MONTANA FISH, WILDLIFE & PARKS

ADDENDUM NO. 1

MAKOSHIKA STATE PARK WATER SUPPLY
MONTANA FISH, WILDLIFE & PARKS
GLEN DIVE, MONTANA
FWP #76652
I.E. #S19-00-115

DATE ISSUED: July 1, 2020

Sheet C-2

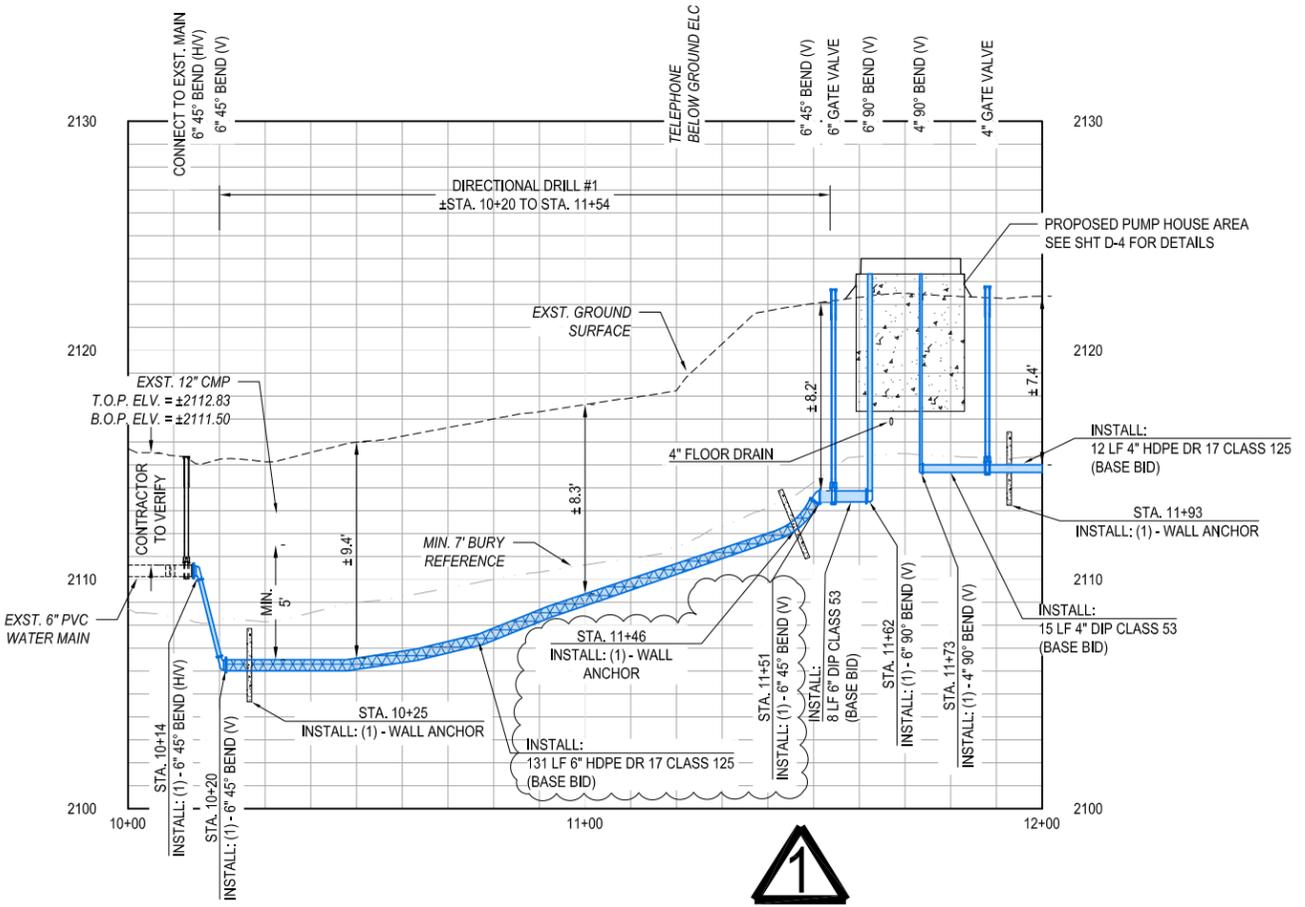
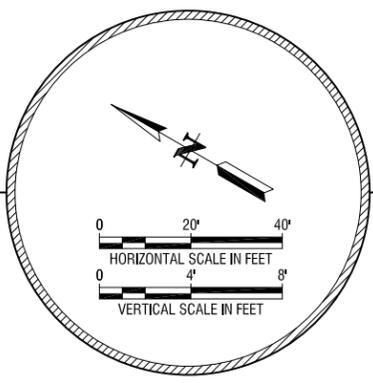
- Item 6: 3" HDPE Pipe shall be Iron Pipe Size (IPS).
- Item 7: A 6" vertical 45-degree bend has been added at STA 11+51.
- Item 8: Val-Matic 201C.2 Combination Air Valve is an approved equal to the GA Industries Model 945 Combination air release/vacuum valve.

Please see Revised Sheet C-2.

- Existing gate valve installed in 2020
- HDPE wall anchors
- Ductile Iron Pipe between gate valves
- **Will add a 6" 45-degree vertical bend at STA 11+51 in Addendum No.1**
- C-4 to C-20: P&P
 - Note Directional Drill locations
 - Contractor to choose installation method between drills
 - Flexibility in alignment
 - Minimum 5-foot clearance between top of new main and bottom of culverts at all crossings
 - Air-Vac Assembly at field-installed highpoints
 - Flushing Hydrant
 - Only one (1) will be installed on the project. Location dependent on Award
- C-12: P&P
 - Frost Free Hydrant Location
- C-17: P&P
 - Walking Path & Cain's Campground Entrance
- C-18: P&P
 - Existing Well Service
- C-19: P&P
 - Frost Free Hydrant Replacement
